SUBJECT: WATTS BAR NUCLEAR PLANT, UNIT 2 – AUDIT REPORT OF
WESTINGHOUSE DOCUMENTS RELATING TO FINAL SAFETY ANALYSIS
REPORT ACCIDENT ANALYSES (TAC NO. ME4620)

REGULATORY AUDIT SUMMARY OF THE
FINAL SAFETY ANALYSIS REPORT SECTION 15 ACCIDENT ANALYSES
WATTS BAR NUCLEAR PLANT, UNIT 2

Figure 3.1-39: 4.6 ft² break without offsite power (0 – 100 s)

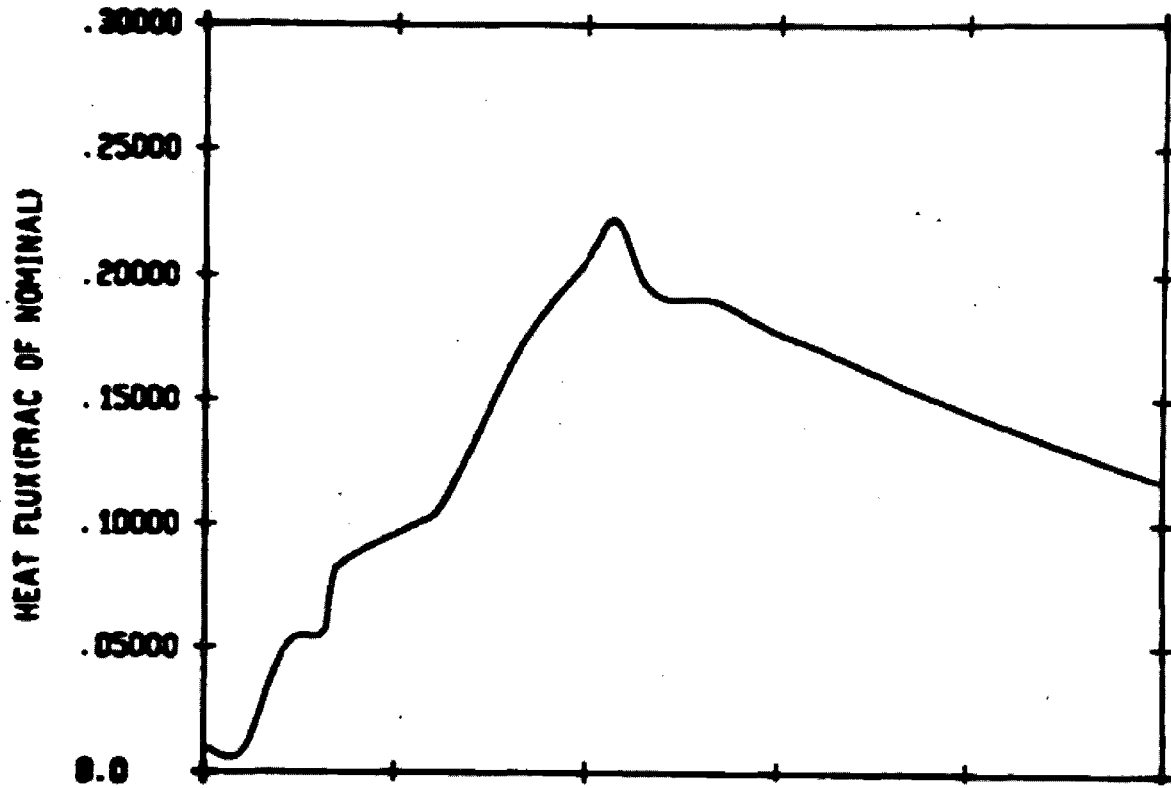
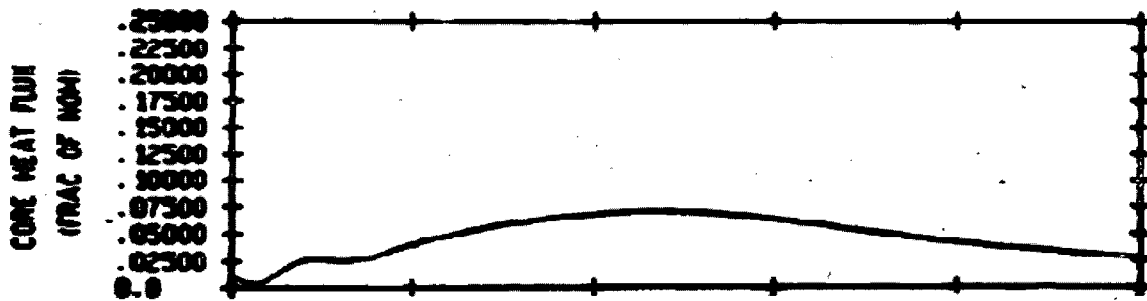
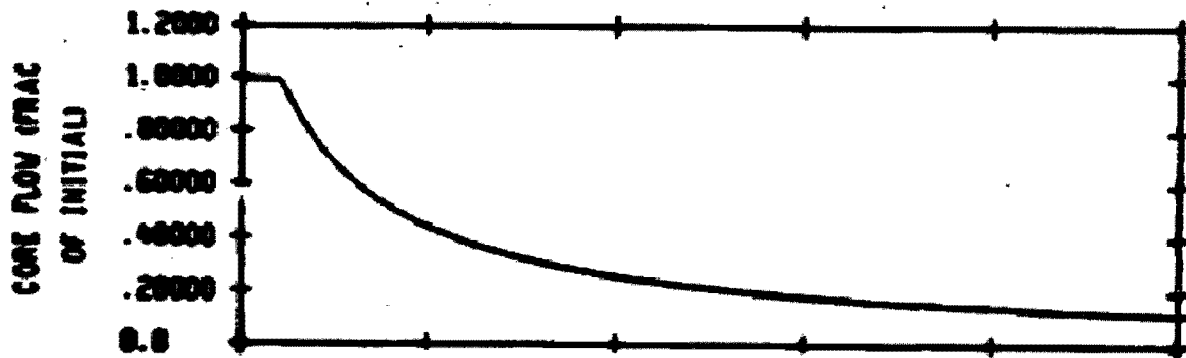
This practice may be the implementation of a conclusion reached in WCAP-9226 § 3.1.1.14, that is based upon the results of steamline break sensitivity studies. WCAP-9226 states, "A comparison of Figure 3.1-39 with Figure 3.1-6 shows that both the core power and core flow are lower for the case without offsite power." Here are Figures 3.1-39 and 3.1-6 from WCAP-9226:

The staff questions whether the WCAP-9226 conclusion, that steamline breaks without offsite power will always be less limiting than steamline breaks with offsite power, would apply to WBN Unit 2, since it is based upon the statement that the peak post-trip power levels for the steamline break analyses without offsite power will always be lower than the peak post-trip power levels for the steamline break analyses with offsite power. The reverse is seen in the WBN Unit 2 steamline break analysis results. This suggests the possibility that the WBN Unit 2 steamline break without offsite power could be the limiting case. Westinghouse has performed the steamline break transient analysis for this case; but hasn't determined its resultant minimum DNBR.

Furthermore, Westinghouse's claim that analyses of steamline breaks without offsite power, using an open channel model with cross flow, "substantiate" the conclusion in WCAP-9226 is not substantiated.

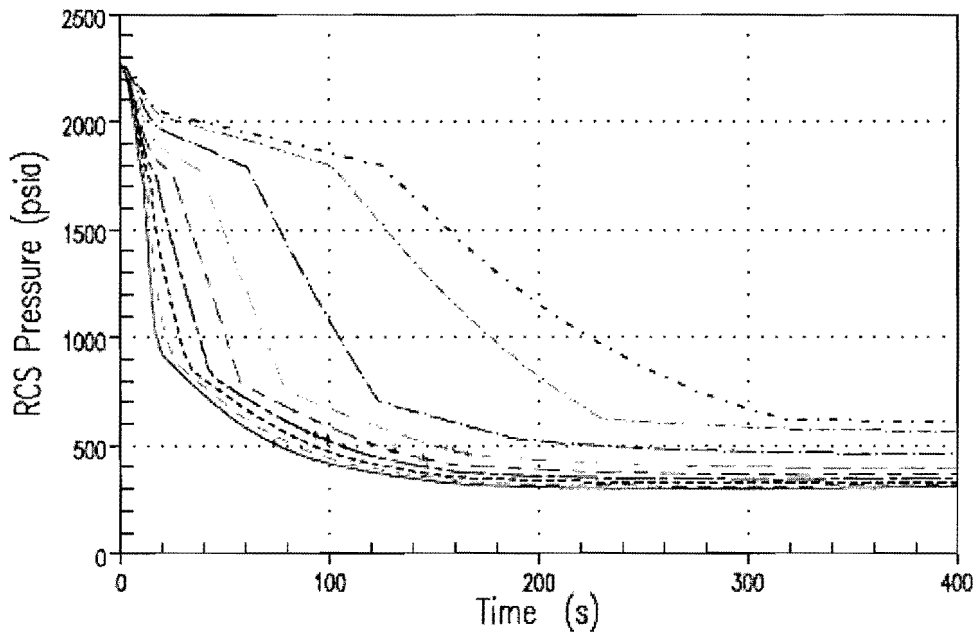
What is the largest steamline break size that would not rapidly depressurize the RCS to the accumulator delivery setpoint (i.e., rapidly enough to make accumulator injection the primary mitigation function)?

Provide a discussion to support the claim that the main steamline rupture is more limiting than the accidental depressurization of the main steam system given that boric acid is supplied to the core by the accumulators in the former case; but not in the latter case.

All breaks assuming offsite power is available will depressurize to the accumulator injection pressure. The smaller (minor) breaks will reach the injection pressure later than the larger (major) breaks and smaller breaks result in less cooldown and a lower peak heat flux and are subsequently less limiting.

All breaks assuming offsite power is available will depressurize to the accumulator injection pressure. The accidental depressurizations will reach the injection pressure later than the main steamline rupture, and smaller breaks result in less cooldown and a lower peak heat flux and are subsequently less limiting.

The applicant supplemented its response with the results of a series of steamline break analyses, performed for various sizes, down to 0.05 ft² (top curve). In each case the accumulator injection setpoint is reached. The smaller sizes reach the accumulator injection setpoint later in the transient.

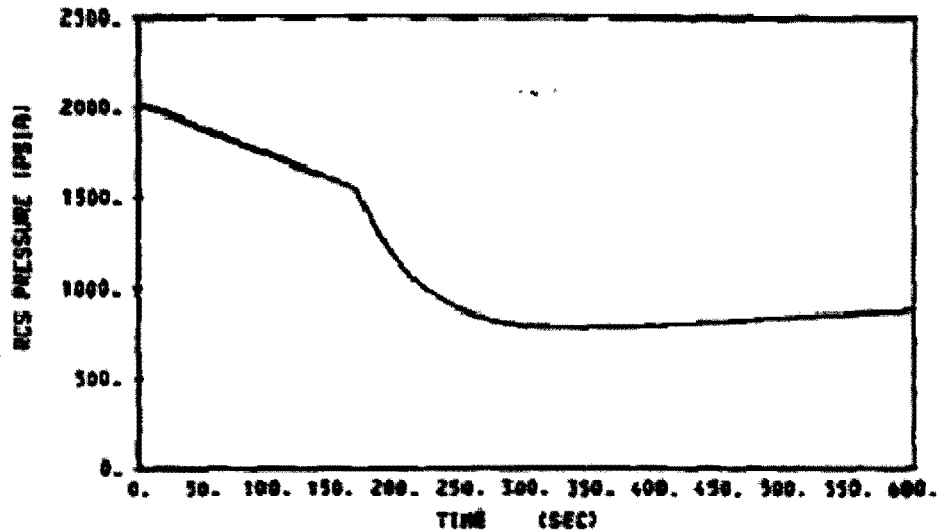
At the audit, the staff produced an RCS pressure transient representing a credible break (i.e., the spurious opening of a steam system valve with a throat area of 0.11 ft²) that was copied from WCAP-12603, Point Beach's report for the reduction of safety injection system boron concentration (September 1990). The Point Beach transient was selected because, like the WBN Unit 2 transient, there is no heat addition (to keep pressure high) due to power generation. The break area is twice the break area of the top curve, and roughly equivalent to the break area of the curve just below the top curve. Since none of these three pressure transients stem from analyses that predict a return to criticality, there is no power generation to retard the depressurization transients. The WCAP-12603 transient (below) indicates that the accumulator setpoint is not reached.

Indeed, it shows the beginning of a trend to pressurize the RCS, which, if allowed to continue, would eventually cause RCS pressure to reach the highest shutoff head of all the operating emergency core cooling system (ECCS) pumps or the opening setpoint of the pressurizer power-operated relief valves (PORVs), whichever is lower. In the case of WBN Unit 2, it would be the opening setpoint of the PORVs (see mass addition event analyses and methods, below). Since the RCS has been cooled by the blowdown of a steam generator, pressurized thermal shock could become a concern.

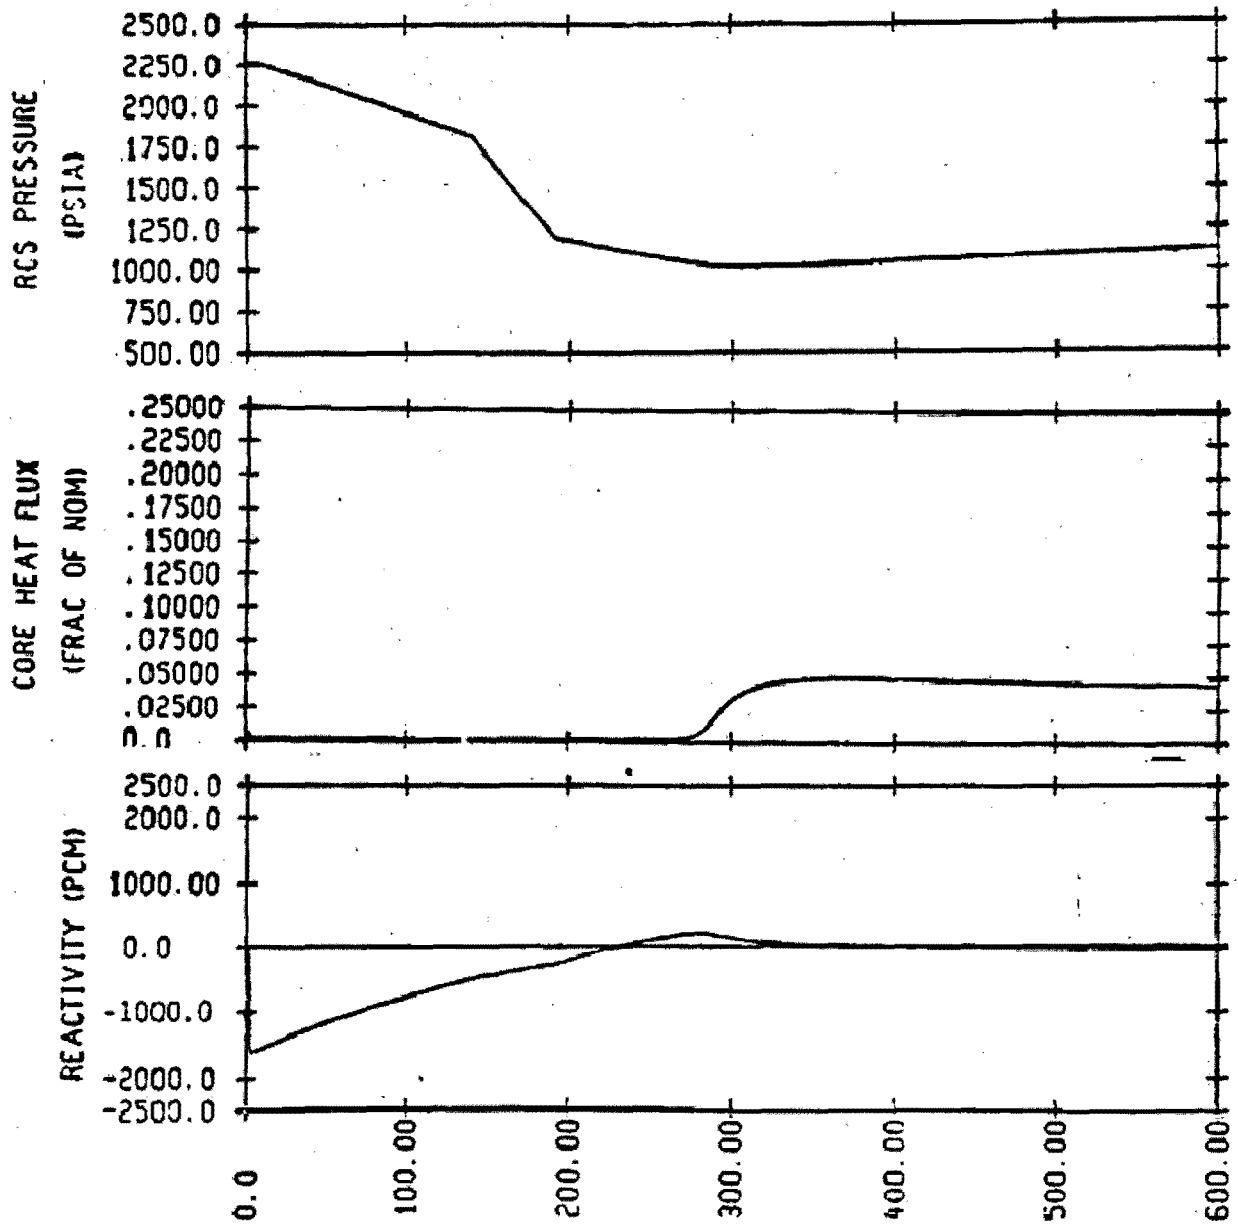
The corresponding steamline break analysis, for WBN Unit 1 (and therefore, WBN Unit 2), is found among the boron injection tank (BIT) concentration reduction case studies conveyed by letter dated May 2, 1984, from TVA to the NRC. The RCS pressure transient resulting from the credible break (0.11 ft²), designated Figure 15.2-41 in the report, and depicted below, is not suitable for comparison to the prior cases, with respect to accumulator injection, since the analysis predicts a return to criticality, which leads to a sustained power generation of almost 5 percent of nominal. Consequently, this heat addition could tend to keep the minimum RCS pressure above the accumulator injection setpoint. As expected, the transient plot shows that the accumulator injection setpoint is not reached. However, it is interesting to note that, in 1984, this analysis predicted that the core would return to critical, whereas today, no return to criticality is predicted. In fact, no return to criticality is predicted for any break size up to and including 0.6 ft².

It was necessary to reach back decades to obtain the results of analyses of credible steamline break cases because Westinghouse no longer includes such analyses among the cases reported in FSARs or other licensing submittals. Today, they're systematically dismissed as being bounded by the major steamline rupture cases. WCAP-9226 examined a range of break sizes; but did not include the credible break size, 0.11 ft². It was not necessary to consider the credible break size because, in 1978 (when WCAP-9226 was issued), Westinghouse adhered to an internal acceptance criterion that did not permit the credible break to cause a return to criticality. Credible steamline break analyses consistently showed that 20,000 ppm boric acid, from the ECCS reached the core before it could reach criticality, and then the high concentration

This is no longer true. In the years following the publication of WCAP-9226, Westinghouse has (1) reduced the concentration of boron in the BIT, and (2) abandoned its internal no-criticality acceptance criterion for credible steamline breaks. Today, credible steamline breaks can result in a post-trip return to criticality. Delivery of ECCS flow to the core no longer causes a steep drop in core reactivity. Instead, core reactivity falls to the critical level, and stays there until core boron concentration builds up to a level that would render the core subcritical, or until the positive reactivity insertion, due to the steamline break-induced cooldown, is ended (i.e., the faulted steam generator is empty, or nearly empty). The plots, below, which result from an analysis of the WBN Unit 1 credible steamline break, with reduced boron concentration in the BIT, are an example of this behavior. Since this resulting power generation could cause the DNBR safety limit to be violated during a credible steamline break, it can no longer be categorically stated that the major steamline break will always bound the credible break. There is the possibility that a small break, that does not cause the RCS to depressurize to the accumulator injection setpoint, could yield a lower DNBR than would a large steamline break, which receives the benefit of boron from the accumulators. This possibility is behind the staff's questions.
